March 29, 2024

Venetin Aghostin
Senior Development Planner
Fairfield City Council
86 Avoca Road
Wakely, NSW 2176

This letter has been prepared by Ethos Urban on behalf of TCON Constructions to provide a response to the Request for Further Information (RFI) issued by Fairfield City Council (Council) dated 21 December 2023. It relates to Development Application (DA) 260.1/2023 which proposes staged development of the site involving construction of multi dwelling housing (MDH) containing 53 dwellings and 1 storey basement, construction of a 6-storey residential flat building (RFB) containing 87 (now 85) apartments with two storey basement, construction of a private internal access road, earthworks, associated landscaping communal open space, tree removal.

Figure 2 (replicated below) of the SSDCP illustrates the location of communal open space (COS) for the RFB and MDH in dark green.

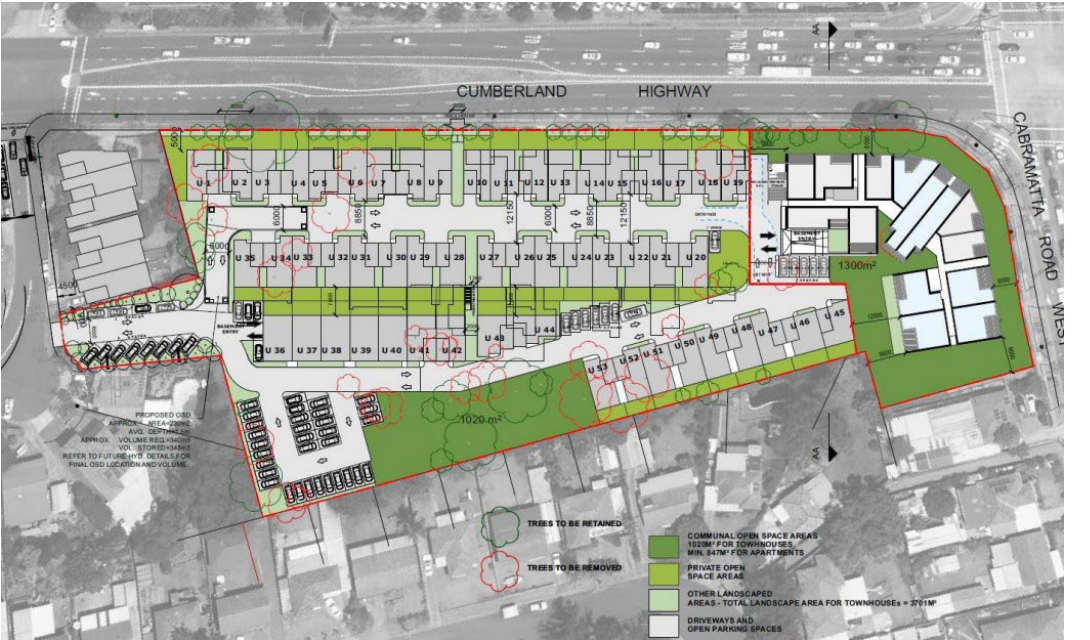
c) Communal open space areas have been reduced to 2 instead of 3. The open space approved at the end of Block F has been replaced with parking and substation and is unacceptable.

Topic	Council matter raised	Applicant response
		Two (not three) communal open spaces are identified – one for the multi dwelling component at the eastern boundary and for the RFB around the periphery of the site. Notwithstanding, the space indicated by Council as being a third communal open space (adjoining MDH U.35), previously shown with parking spaces and a substation in the submitted DA, has been revised to remove marking spaces and relocate the substation and be embellished with landscaping to function as a third COS. Refer plans at Attachment A and Landscape drawings at Attachment K .

All setbacks are compliant with the ADG as illustrated below (ADG reference numbers shown). It is important to note that walls with windows at 1.8m sill height are treated as non-habitable, as a resident cannot look through a window at this height. Refer additional detail at **Attachment D**.

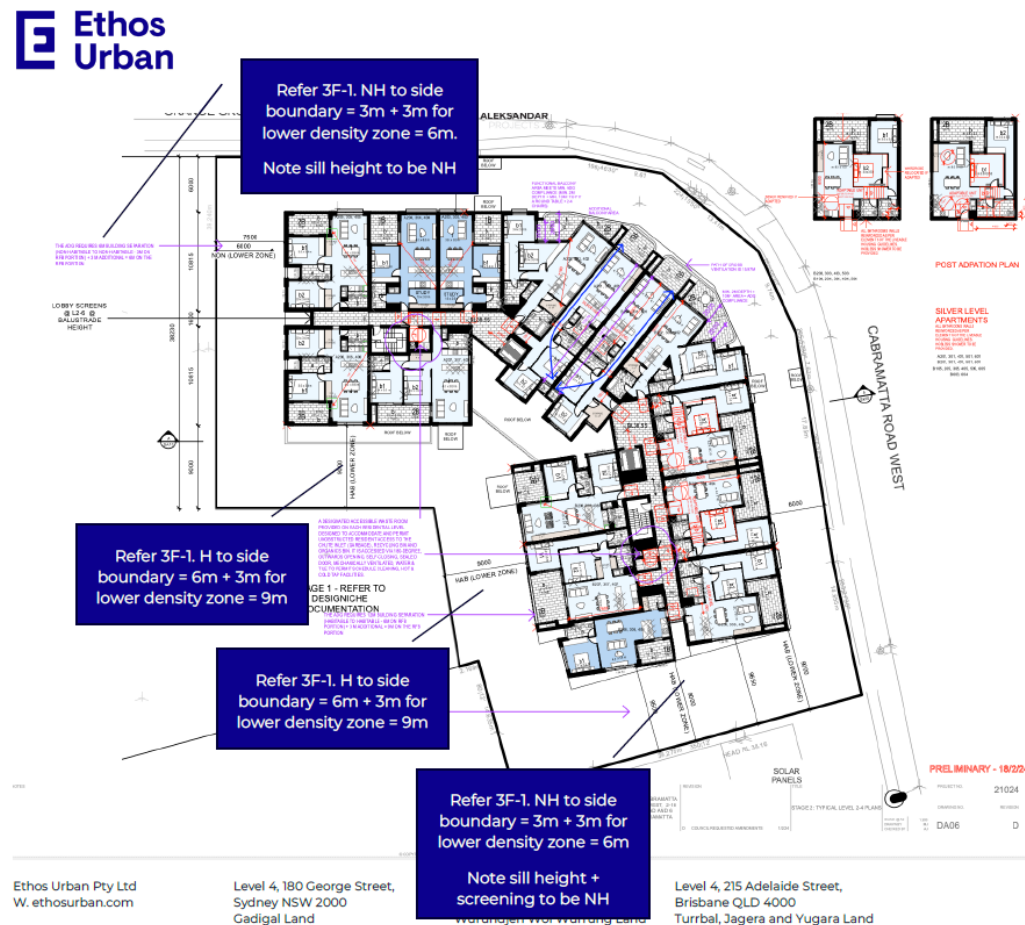
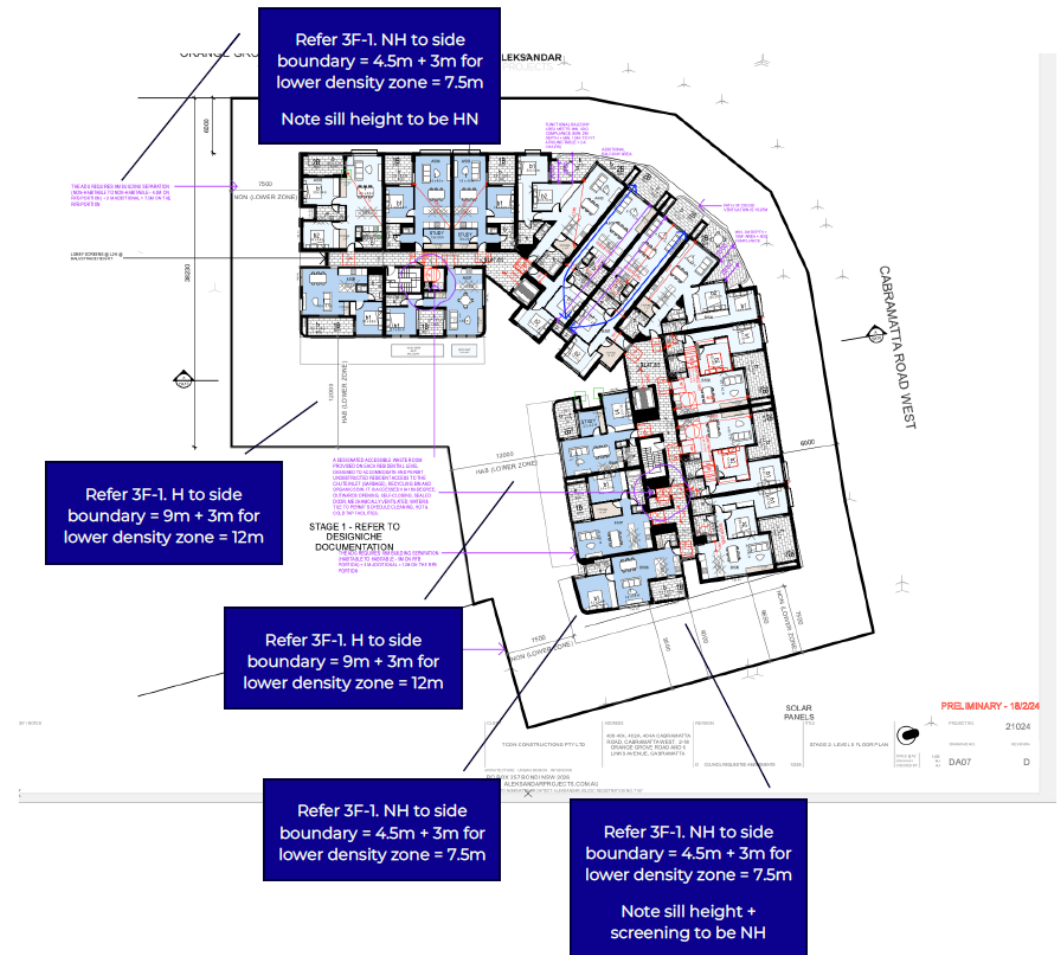
ii. RFB does not provide the minimum 9m setback to the proposed R3 zoned MDH on the same site. Levels 5 and 6 do not provide a 12m setback to the proposed MDH.

Levels up to 4 storeys:

Levels 5 and 6:
